Executive Summary Downtown Project Authorization

Date: August 6, 2015
Case No.: **2013.0159X**
Project Address: **525 HARRISON STREET**
Zoning: RH-DTR (Rincon Hill Downtown Residential) Zoning District
Existing Height/Bulk: 65-X & 65/400-R Height and Bulk District
Proposed Height/Bulk: 65-X & 65/250-R Height and Bulk District
Block/Lot: 3764/063
Project Sponsor: Steve Vettel, Farella Braun + Martel, LLP
235 Montgomery Street
San Francisco, CA 94104
Staff Contact: Richard Sucre – (415) 575-9108
richard.sucre@sfgov.org

The proposed project includes demolition of the existing two-story former industrial building (27,500 gsf), and the new construction of a 23-story residential building (approximately 255,468 gross square feet; up to 250-ft tall) with up to 205 dwelling units, 1,000 square feet of ground floor café/retail, 103 off-street parking spaces, 127 Class 1 bicycle parking spaces, and 20 Class 2 bicycle parking spaces. The project includes a dwelling unit mix consisting of 94 two-bedroom units, 69 one-bedroom units, and 42 studio units. The proposed project includes approximately 15,683 square feet of open space via ground floor street improvements, private balconies, a podium

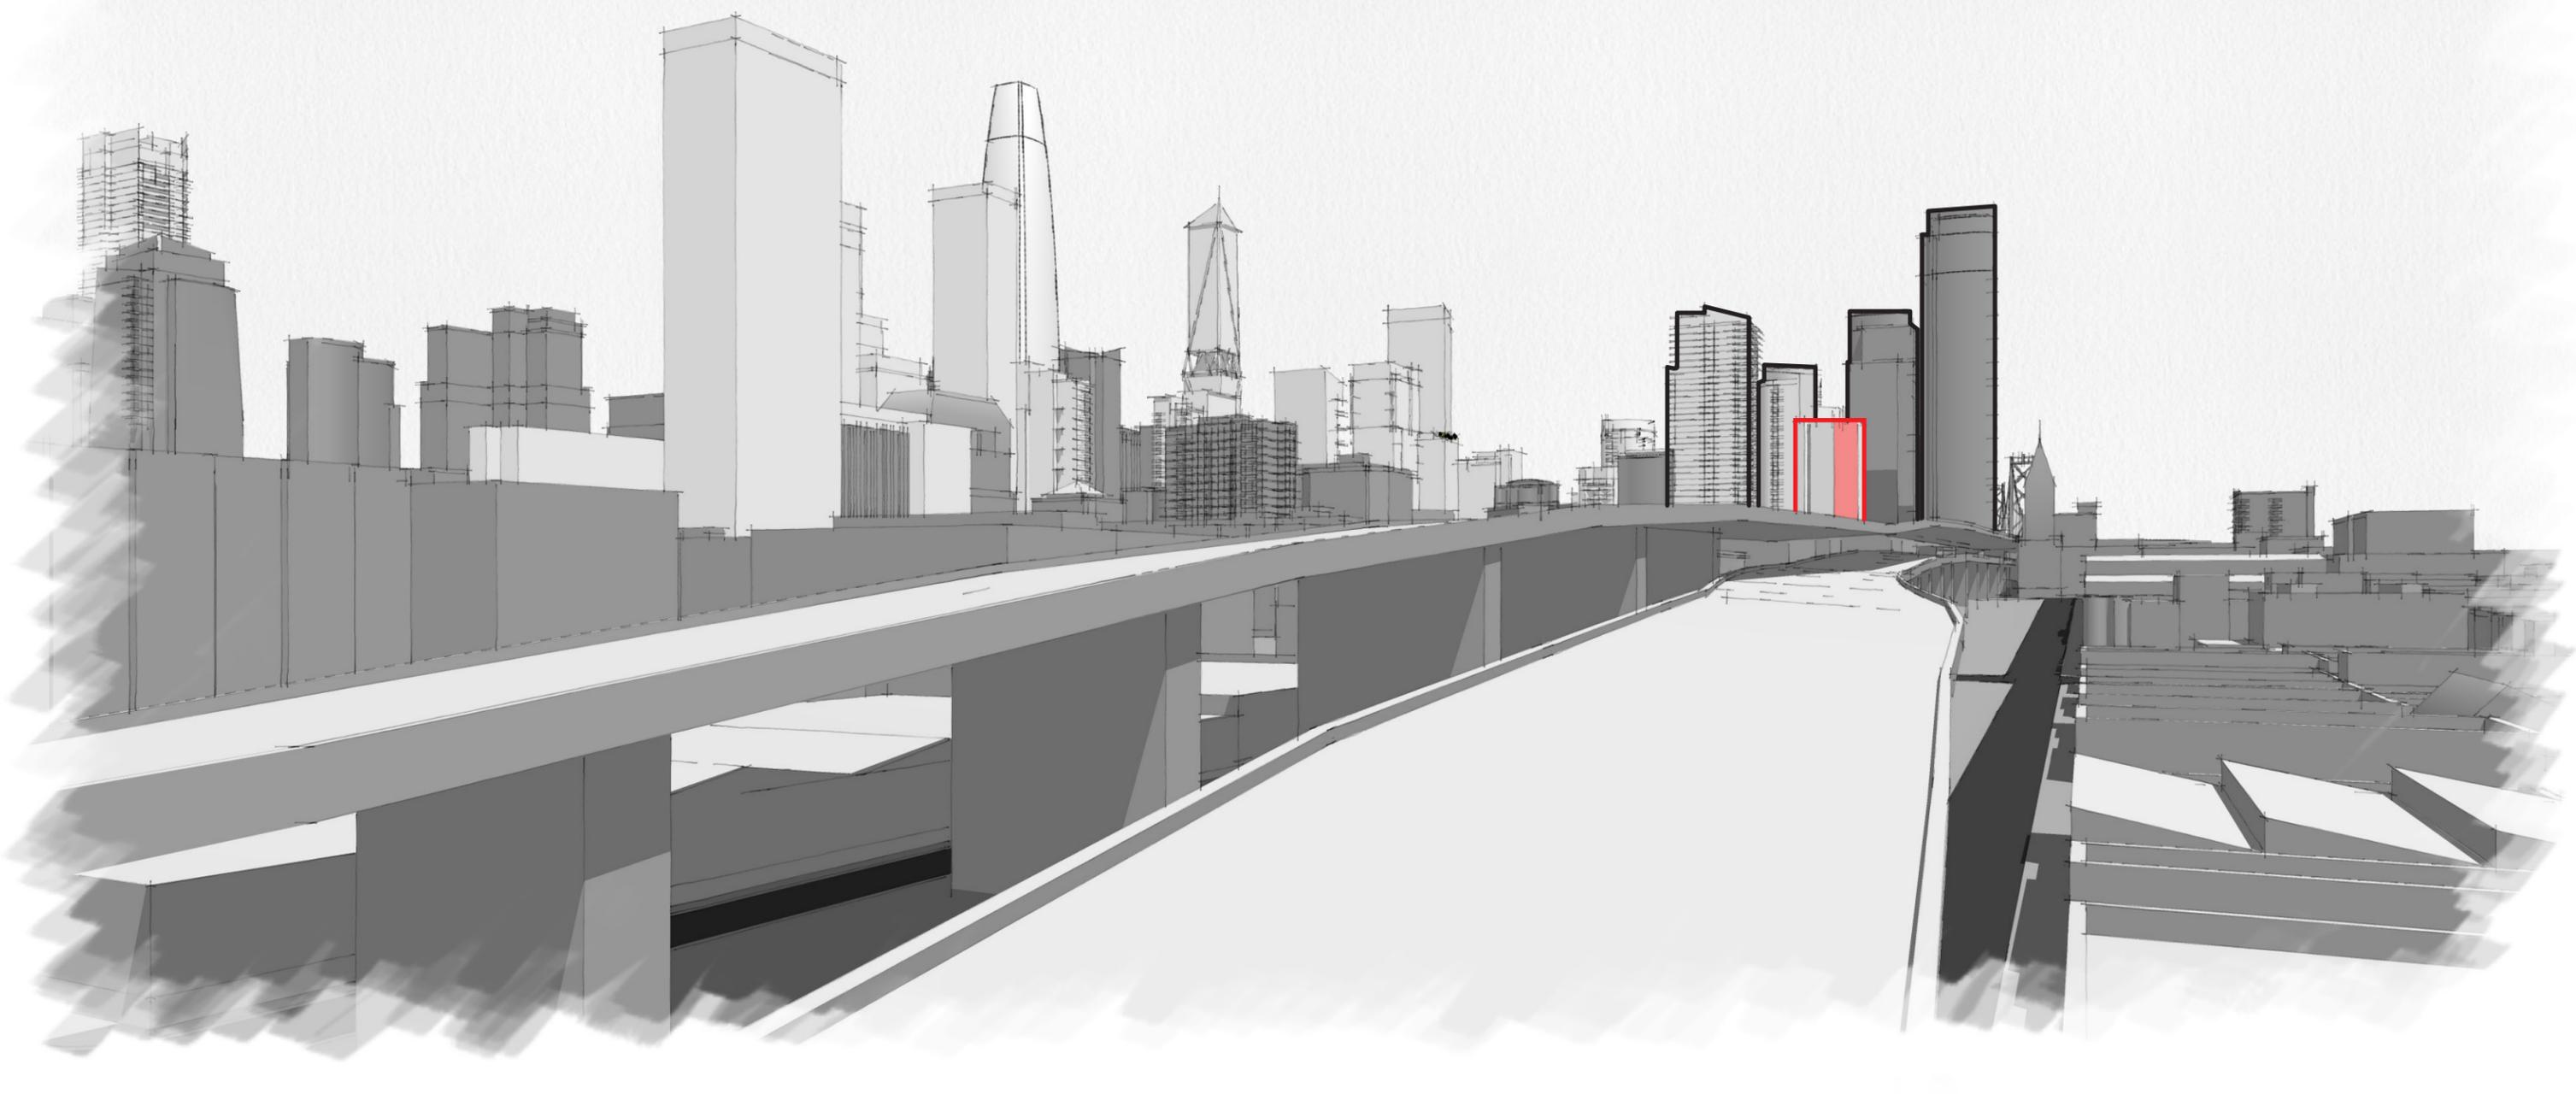
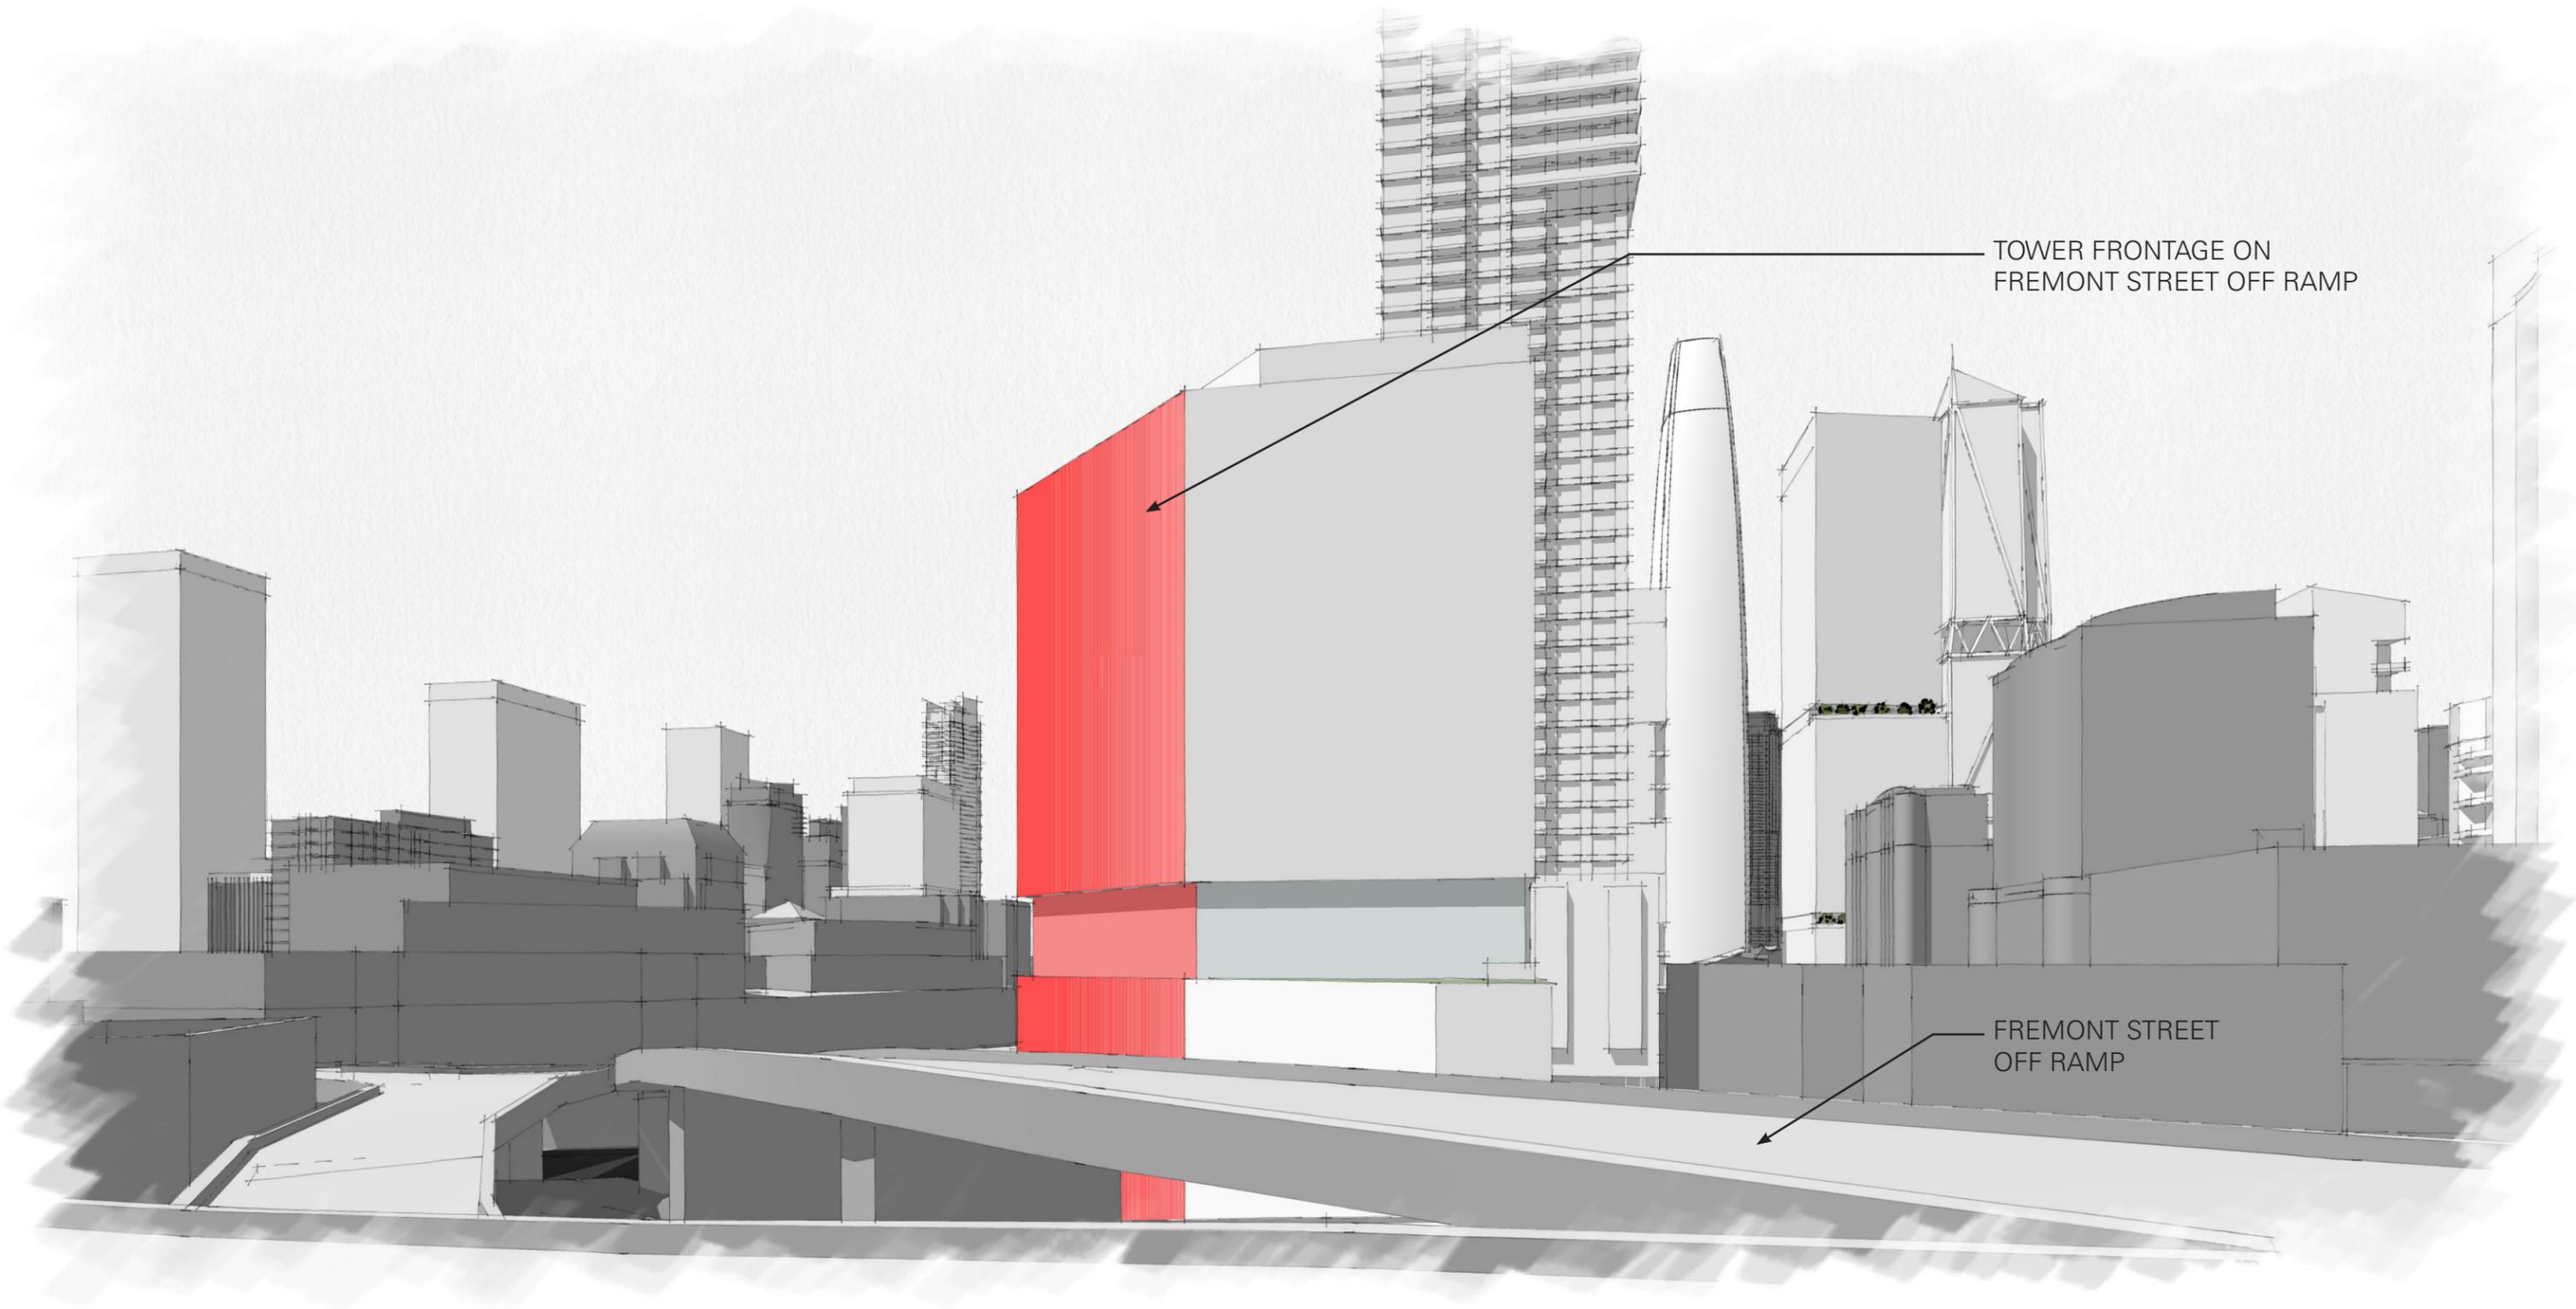
PLANNING COMMISSION COMMENT: THE HEIGHTS OF THE NEIGHBORING BUILDINGS STEP DOWN FROM THE TOP OF RINCON HILL TO THE EDGE OF THE NEIGHBORHOOD WHERE THE BUILDING IS LOCATED. THE PROJECT, AS DESIGNED, DOES NOT REINFORCE THIS STEPPING PATTERN ON THE SKYLINE. THE PLANNING COMMISSION WOULD PREFER TO SEE A BUILDING IN THE 200' - 300' RANGE THAT BETTER ADDRESSES THIS EFFECT.

HAVING STUDIED SEVERAL MASSING STRATEGIES THE BUILDING IS NOW 250' TALL AND PROVIDES A STRONG VISUAL TRANSITION FROM THE RINCON HILL TOWERS TO THE MID RISE BUILDINGS IN THE ADJACENT NEIGHBORHOODS.
